Juneau Access Improvements Project Draft Supplemental Environmental Impact Statement

2014 Update to Appendix D Technical Alignment Report

As part of the JAI Project 2014 Draft Supplemental Environmental Impact Statement (SEIS), additional changes and updates to design criteria, plans, and costs have been prepared and are presented in this *2014 Update to Appendix D – Technical Alignment Report*. This Update incorporates and replaces the 2006 Addendum to Appendix D. The information reported in the 2004 Technical Alignment Report Appendix D remains valid unless replaced with new information presented in this Update.

Figure 3-1: Typical Roadway Section

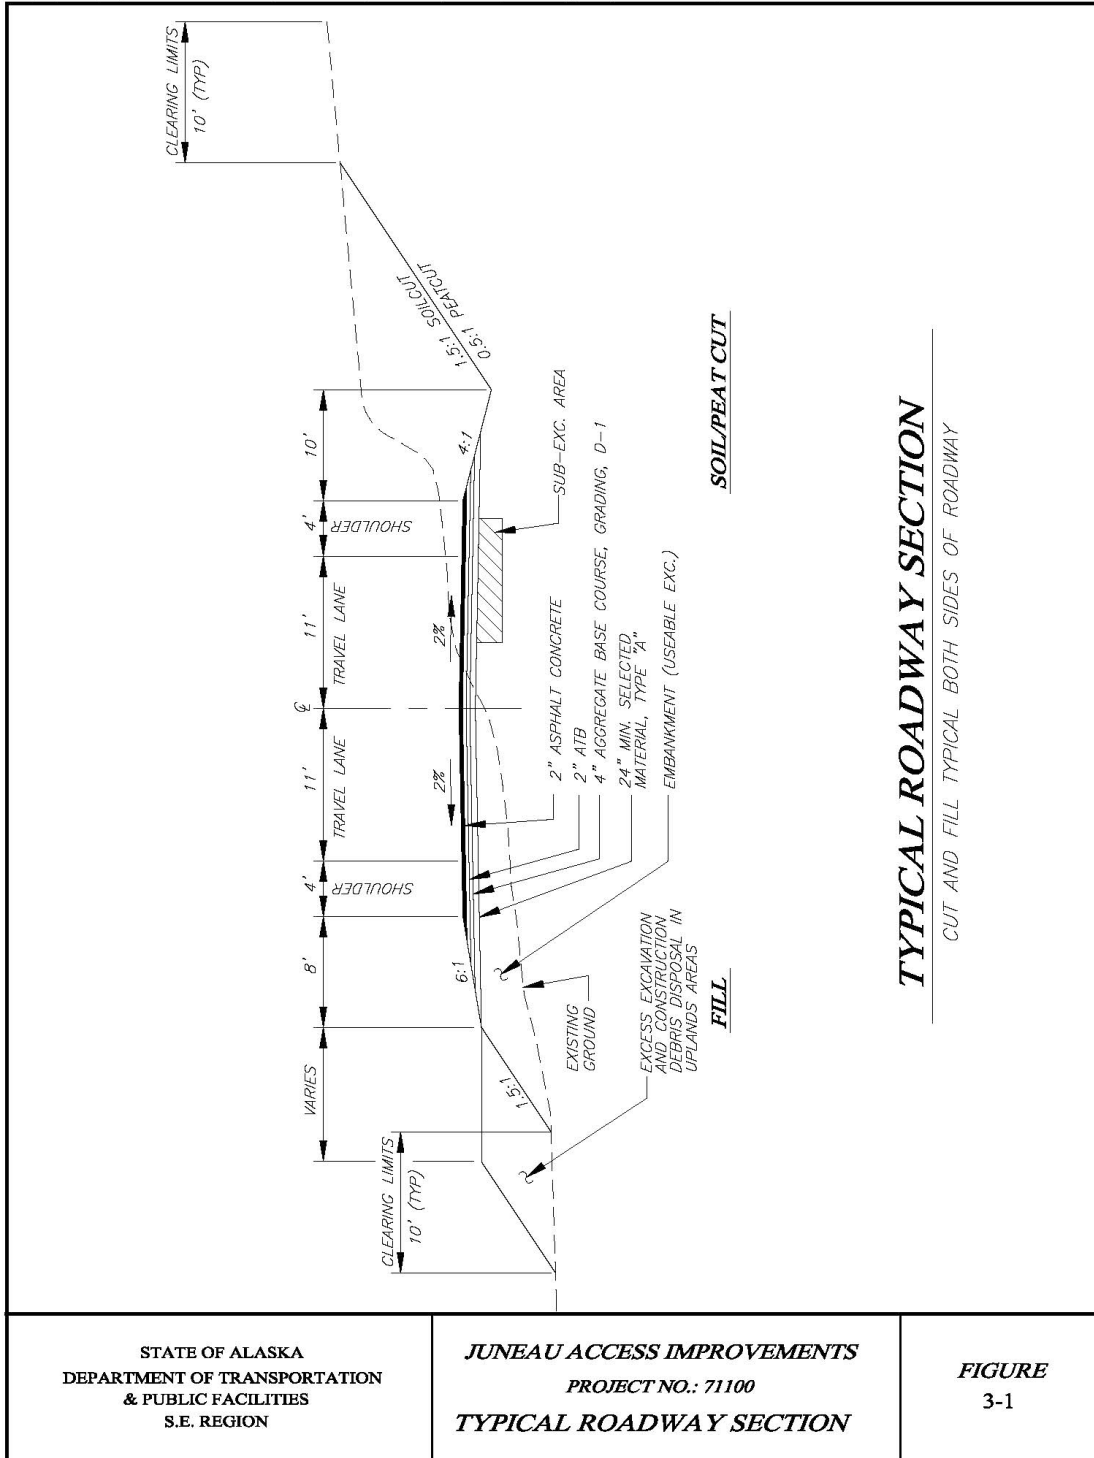
The highway typical section has been revised to replace the 4-inch-thick layer of Emulsified Asphalt Treated Base (EATB) with 2 inches Asphalt Treated Base (ATB) and 4 inches Aggregate Base Course, Grading D-1. The combined ATB and Base Course will provide a more durable structural section. The ATB and Base Course have been included in the Engineer's Estimates for all alternatives and are shown on the typical sections.

Select material below the base and pavement section has increased from 12 inches to 24 inches where the road is constructed on frost susceptible soils. Providing a non-frost susceptible material below the road base is critical in preserving the integrity of the road structure and will minimize long term maintenance efforts.

The ditch width has increased from 8 feet to 10 feet. The wider ditch width will better accommodate subsurface drainage from the 24-inch select material to the ditch and provide more capacity for drainage and snow storage.

The attached Figures 3-1 through 3-6 reflect this change and provide information on various typical sections.
